Petition Number: #2021-277

From: Jake Carpenter, PE

Revision Log:	Date	Description		
	05-18-2022	First Review (WB)		
	09-21-2022	Second Review (AO)		
	10-26-2022	Third Review (IW)

Transportation Summary

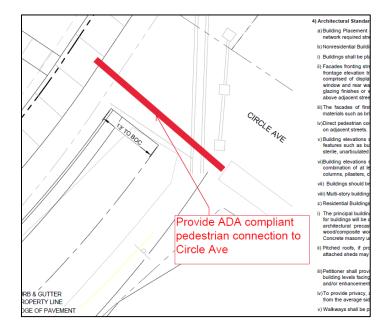
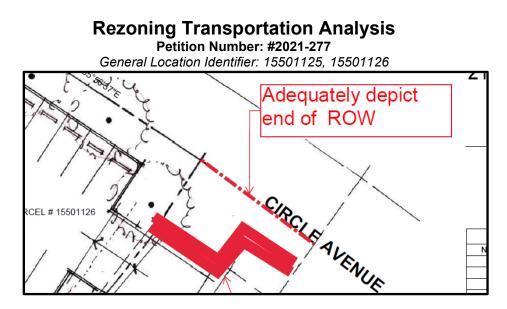
6. **Outstanding Comment from 5-18-22:** Site plan and conditional notes revisions are needed to provide an ADA compliant pedestrian connection from Phill Aull Place to Circle Avenue.

Clarifying Comment 10-27-22: Label and add conditional note committing to ADA compliant connection.
